Access Compliance Report

Public Rights-of-Way

(Curb Ramps)

Intersection ID: N/A	Main Street: YORK_CENTER_DR	Cross Street: N/A	Location: NW
ADA ID: 12545D6D7C40	Ramp Type: PerpDiag	Initial Pass/Fail: Fail	Overall Compliance: No
Codes/Mitigation Info/Possible Solution		Field Measurements/Component Compliance	
Severity Score: 21.25

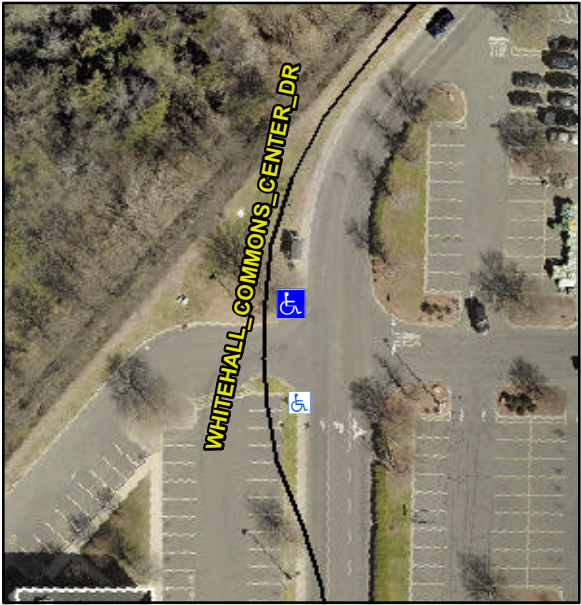
Possible Solutions:		Compliance		Description		Data	Compliance	Description	Data
	Remove & Replace Curb Ramp With Two New Directional Ramps or Equivalent.		N/A		Ramp Length (in)		24.0	No	Ramp Slope (%)	9.0
Surveyor Notes: N/A PROW/ADA: Not Found, R304.5.1, R304.2.2			No		Ramp Width (in)		44.0	Yes	Ramp XSlope (%)	1.5
			N/A		Flare Type LT		N/A	N/A	Flare Type RT	N/A
Street 1 Name ENTRANCE Stop Condition-Street 2 None Street 2 Name YORK CENTER DR Stop Condition-Street 1 None			N/A		Flare Slope LT (%)		N/A	N/A	Flare Slope RT (%)	N/A
			N/A		Flare Traversable LT?		N/A	N/A	Flare Traversable RT?	N/A
Total Cost: \$ 3200.00			N/A		Landing Length (in)		N/A	N/A	DWS Provided?	N/A
			N/A		Landing Width (in)		N/A	N/A	DWS Contrast?	N/A
			N/A		Landing Slope (%)		N/A	N/A	DWS Length (in)	N/A
			N/A		Landing X Slope (%)		N/A	N/A	DWS Full Width?	N/A
			N/A		Landing Curb? (Y/N)		N/A	N/A	DWS Offset (in)	N/A
			N/A		Shared Landing?		N/A

N/A		Gutter Ponding?		N/A	N/A	Gutter Slope (%)	N/A
			N/A		Gutter Lip Ht (in)		N/A	N/A	Gutter X Slope (%)	N/A
			N/A		Painted X Walk1?		No	N/A	Painted X Walk2?	No
					X Walk 1 Direction		To S		X Walk 2 Direction	To E
			N/A		X Walk 1 Width (in)		N/A	N/A	X Walk 2 Width (in)	N/A
					X Walk 1 Slope (%)		0.9		X Walk 2 Slope (%)	0.2
					X Walk 1 X Slope (%)		0.7		X Walk 2 X Slope (%)	0.9
			N/A		Ramp inside XWalk1?		N/A	N/A	Ramp inside XWalk2?	N/A
					Road Slope (%)		1.0	N/A	Clear Space?	N/A
					Road X Slope (%)		0.2	N/A	Clear Space to XWalk (in)	N/A
			N/A		Any Obstructions?		N/A	N/A	Storm Grate/Utility Hazard?	N/A
					Obstruction Type				Storm Grate/Utility Type	
								N/A		N/A
								Yes	Surface Condition? (G/P)	Good
